Access Compliance Report Public Rights-of-Way (Curb Ramps)

Main Street: COURTNEY_CIR		Cross Street: MAYBECK_LN		Location:	W
ADA ID: RPRK211025113818	Ramp Type: Type 4 - Parallel	Initial Pass/Fail: Fail	Overall Compliance: No	Severity Score:	32
Codes/Mitigation Info/Possible Solution			Field Measurements/Component Compliance

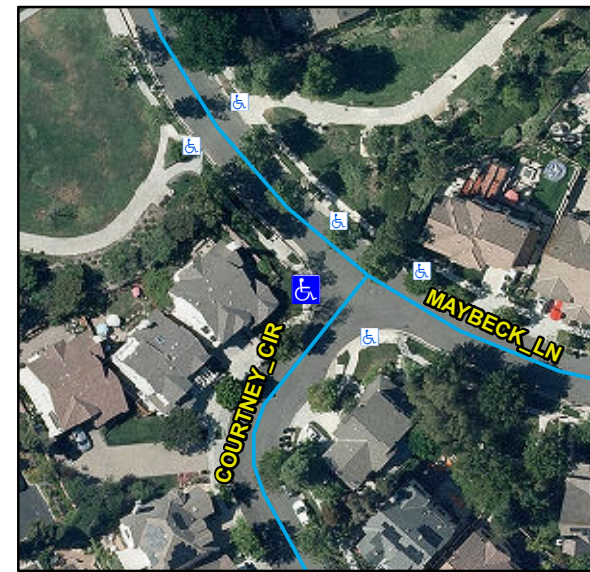
R204.3, R304.3.2, R304.5.3, STD 1115

Remove & Replace Curb Ramp With Two New Directional Ramps or Equivalent.
